## Process/Product Change Notification

### Polymer Surface Mount Capacitors Marking Change *PCN Notification*

<b>Date:</b> 28 <sup>th</sup> June 2016	<b>ID Number (DDMMYY):</b> PCN-KO28062016-UMQ
<b>Affected Products</b>	<p>All KEMET Ta Polymer surface mount series (all part numbers &amp; case sizes) from below Series:</p> <ul style="list-style-type: none"> <li>Industrial Grade Series: T525, T528, T530 &amp; T545</li> <li>Automotive Grade Series: T598</li> </ul> <p>Exception in applicable to special drawing design including: 4539/4125 and NTXX, NTTY, 7133 &amp; 7333</p>
<b>Change</b>	<p>KEMET is starting a standardization process of the marking (polarity band and text content) for the Polymer Surface Mount Capacitors. The polarity bar will change according the <b>attachment I</b>.</p> <p>This change has no impact in:</p> <ul style="list-style-type: none"> <li>Part Number,</li> <li>Form, fit, electrical properties, or function of these capacitors.</li> </ul> <p>KEMET does not expect any re-qualification for this marking change. The appearance is changed to new marking content.</p>

*Industrial Grade Series*

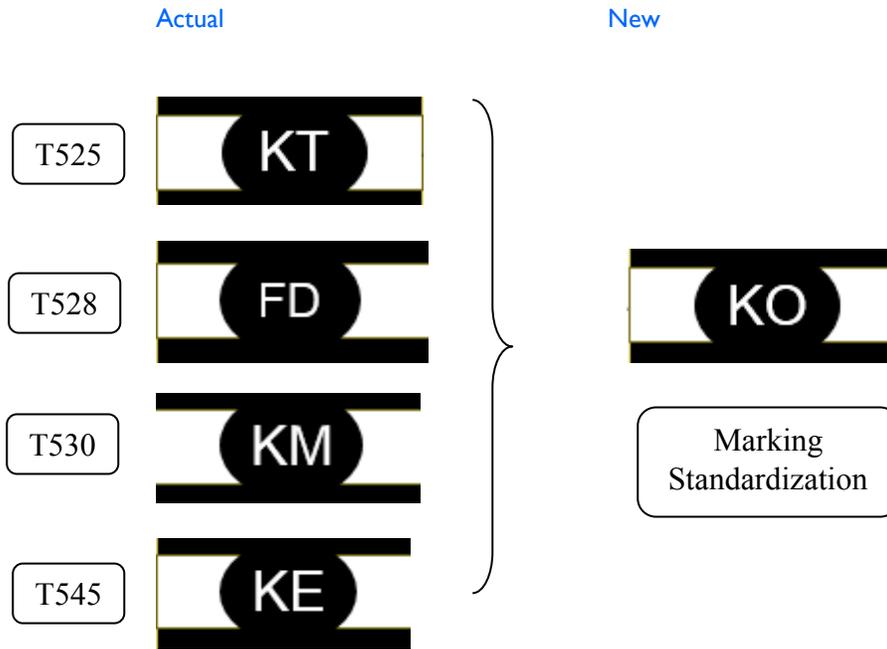
**Attachment 1 – Description of Marking Changes**
